ECN/PCN No.: M1225

Product Description: Multilayer Ferrite Chip Bead	Abracon Part Number / Part Series: ACML-0603 Series	☐ Documentation only ☒ ECN ☐ EOL	☒ Series ☐ Part Number
Affected Revision: G	New Revision: H	Application:	☐ Safety ☒ Non-Safety

6.0 Packing

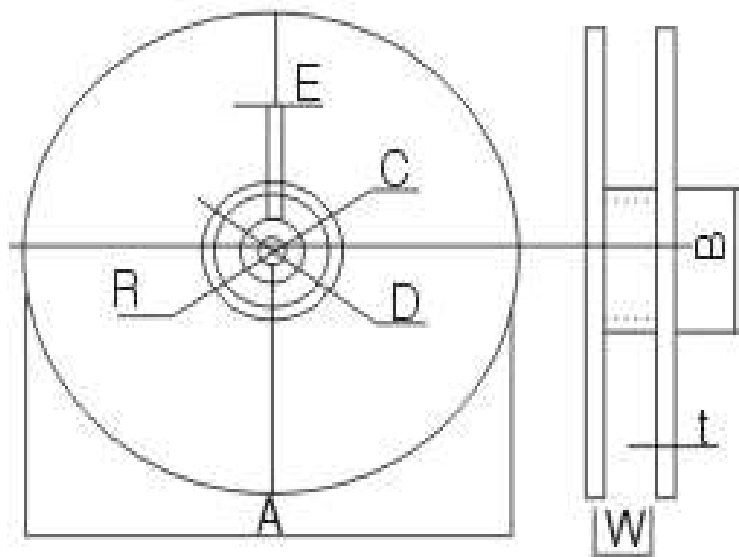
A	178±2
B	60±2
C	13.0±0.5
D	21.0±0.8
E	2.0±0.5
W	10.0±1.15
t	1.2±0.2
R	1.0±0.25

Cause/Reason for Change: Update to the rated current and DCR for some parts, new devices added to the series, 1 part has been EOL'd (ACML-0603-190-T), storage temperature range, and reel dimension graphics.
